Discussion

Professor A. H. Naylor described the model investigations which had been started after the 1948 sea wall had been designed and was under construction. The questions to be answered in order of urgency were :—

FIG. 37.—HALCROW WALL No. 2

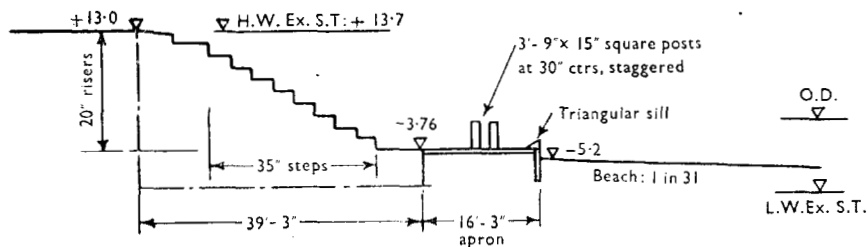
Further experiments were made to discover the optimum wall design. The best proved to be that known as “Halcrow No. 2” (Fig. 37) with a toe protection similar to the optimum of the previous tests. Why was that design not adopted for the subsequent work?

With regard to Professor Naylor's comments, Mr Toms had given the main reasons why the Halcrow No. 2 wall had not been adopted. It should be borne in mind that the working period for all those works had been very limited and simplicity of construction had played a large part in design. It had been essential to keep to the minimum the extent of formwork and in-situ concreting that would be covered by the sea at each tide.

FIG. 39.—PORTION OF A MAP DEALING WITH UNDERGROUND WATER IN THE DOUR WATERSHED

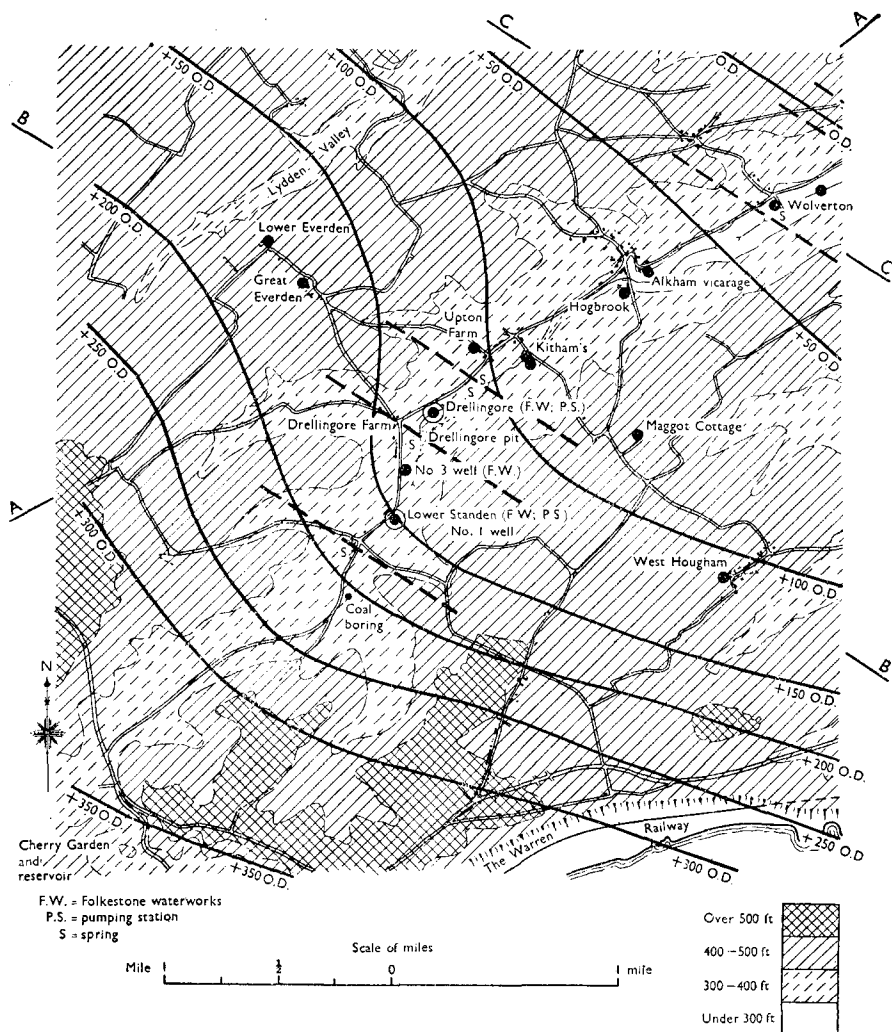
Fig. 39 showed part of a map of the River Dour catchment (situated immediately to the north-north-east of the Warren) which had been prepared in connexion with a waterworks survey. The full heavy lines

running in the general direction north-west to south-east were contours of the base of the Middle Chalk formation (the top of the Plenus Marl). They showed a general dip to the north-east, but nearer the Warren it was to the north-north-east, and in dry conditions when water was not plentiful that was the direction in which water tended to move ; but it did not travel at the low levels, because the Chalk was almost completely impervious in its lower parts. Geologists had divided the Chalk into Upper, Middle, and Lower, but from the waterworks point of view the effective division was half-way down the Middle Chalk. Above that there was a great deal of percolation, but below half-way down the middle chalk it was almost completely impervious and the movement of water was confined to the fissures.

FIG. 29

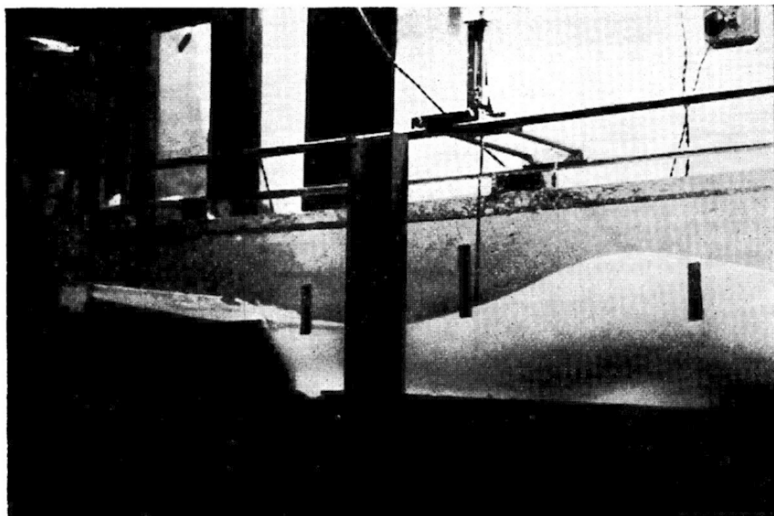
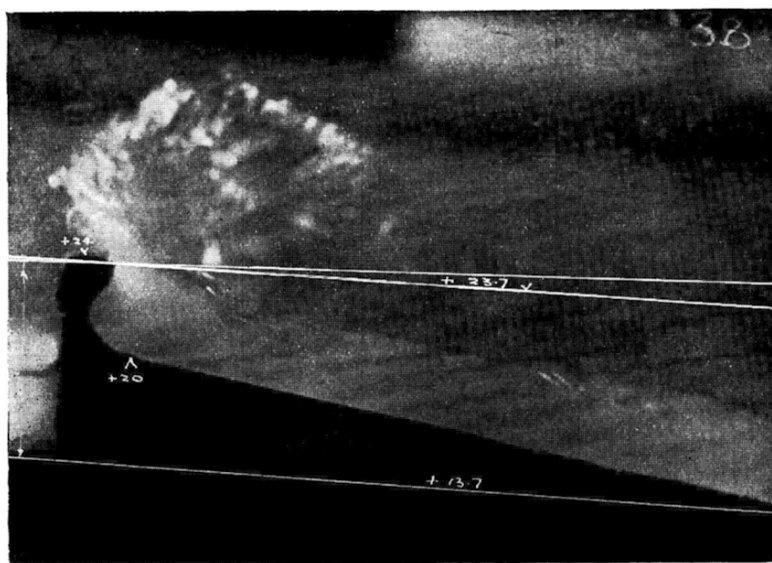
The top covering was assumed to be terminated 50 feet back from the wall. Fig. 29* showed a plain apron with a 4-foot-high end wall and Fig. 30 showed it to be inadequate to prevent overspill. Figs 31, 32, and 33 showed the effect of three 2-foot-square baffle walls. There was but little overspill.

FIG. 34

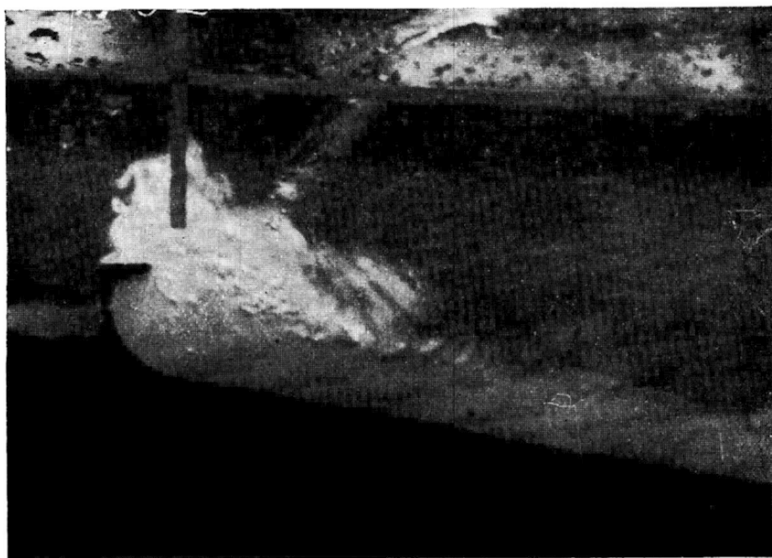
Fig. 34 showed a plain apron with a 5-foot wall. An improvement was to cut out the eurved fillet at the base of the wall. Further improvements were effected by bringing the wall forward and by introducing baffles consisting of rows of cubes.

FIG. 41.—DISTORTED SECTION ON LINE OF CIRCULAR TUNNEL HEADING

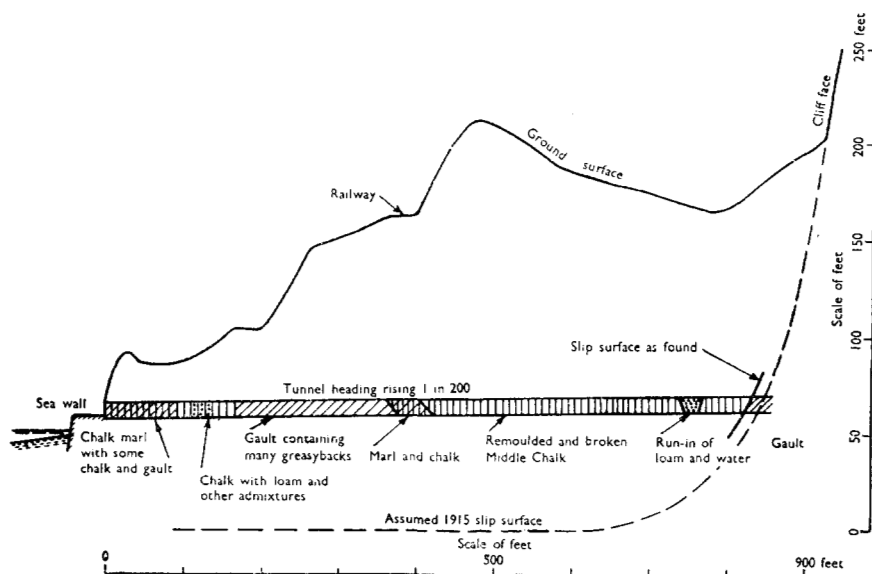
Fig. 41 was a distorted longitudinal section of the new tunnel heading, showing the Gault barrier passed through before entering the Chalk. Relatively little water had been encountered until the loam pocket was struck, when there had been an uncontrollable " run-in " which delayed the work for about 3 weeks. Thereafter the heading passed through broken chalk until it struck the 2-to-3-inch-thick remoulded slip surface at the Chalk Gault contact face. Fig. 42 showed the strength of undisturbed samples prepared from large pieces of the Gault taken from the slip surface and at various distances behind it up to the termination of the shield chamber. The samples had been cut out by hand, not with a sampler tube, and carefully waxed up to prevent any loss of moisture before preparation for testing.
